Fix for STK600 32 kHz Oscillator

User Guide

Rev. 8177A-AVR-07/08

Figure 1-2. Manufacturing date.

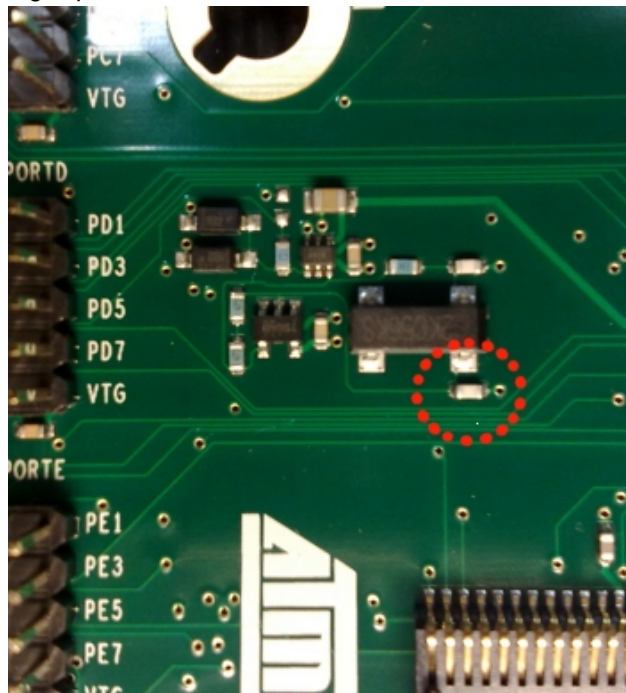
The manufacturing date for the board can be found on the sticker on the bottom side of the board.
